Z-56
(2017)

PROVENCE ESTATES
REZONING PLAN

PETITION NO.: Z-56

ZONING COMMENTS:

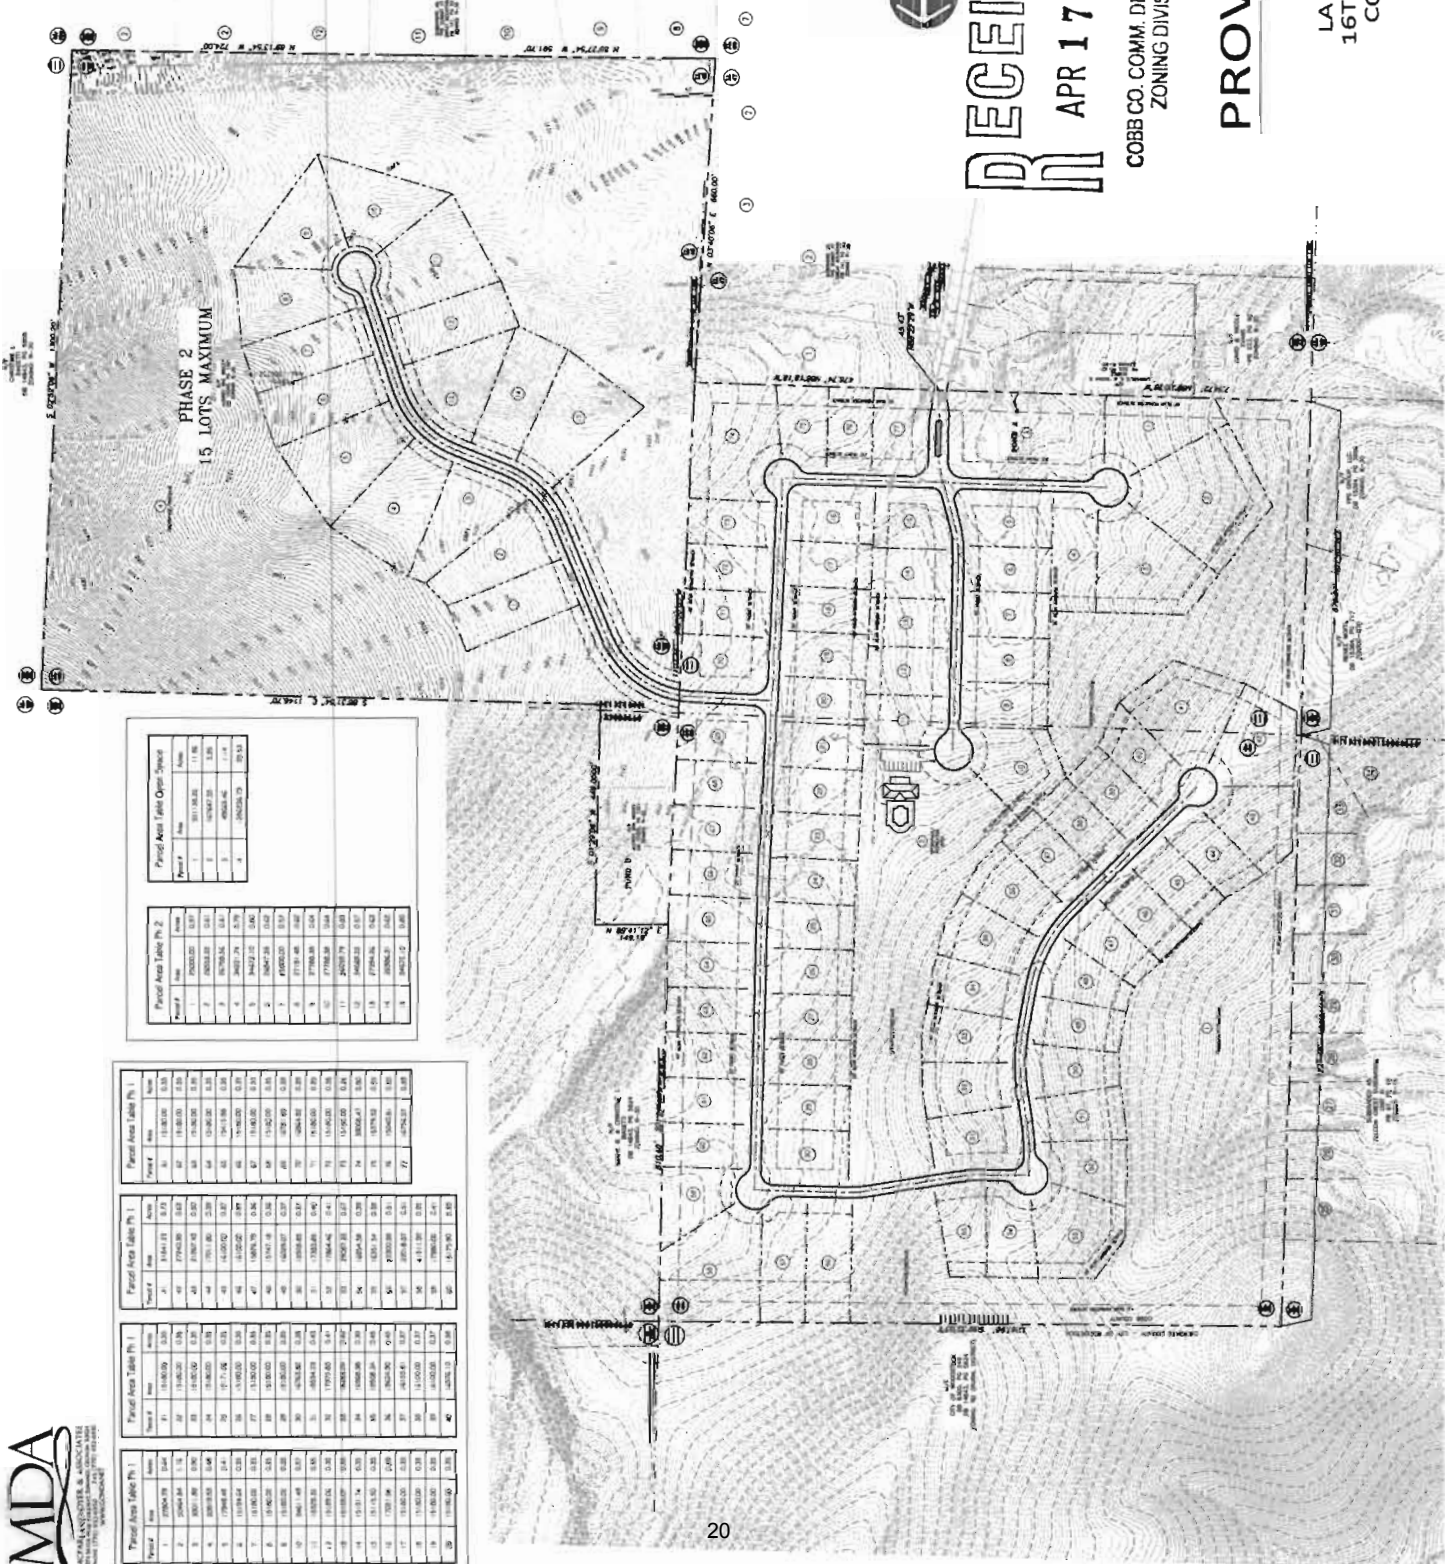
- 1.) Impervious surfaces of amenity areas should be subtracted from the total area to determine Net Buildable Area. Please provide acreage of the impervious surface of amenity area. Also, please note on plan that no floodplains, wetlands and/or cemeteries are evident on site, if that is indeed the case.

- 2.) Proposed open space on site plan (46.48 acres or 48.3%) does not match the percentage open space that is referenced in Item #1 (45%) in the April 17, 2017 stipulation letter.

- 3.) Slopes greater than 25 percent must be included in the required open space, but shall allow for perpendicular (except when non-perpendicular is necessary to satisfy drainage/storm water requirements) utility and access crossings, when necessary. Based on GIS generated slope analysis, there are several lots that encroach into slopes greater than 25%.

- 4.) The buffer area on the southern and eastern portions of the subject property show 40 foot. Item #2 of the April 17, 2017 Stipulation letter says 50 foot. Please show 50' undisturbed buffer along the southern and eastern portions of the subject property, as well as to the rear of lots 42 and 43 on the western side of subject property.

- 5.) Allow pedestrian access to the open space pocket located in the southwest portion of the tract (likely to the rear of lot 10).
- 6.) Either on the plan or in stipulation letter include language referencing fencing that is compatible with the architecture/landscape/design of development shall be established along lot lines that are contiguous to open space.
- 7.) A Conservation Easement must be recorded in the mandatory subdivision covenants and with Cobb Superior Court, thereby protecting the “Open Space” from development in perpetuity as owned by the mandatory Home Owners Association. Conservation Easement application must be submitted to the Planning Division before final plat approval.
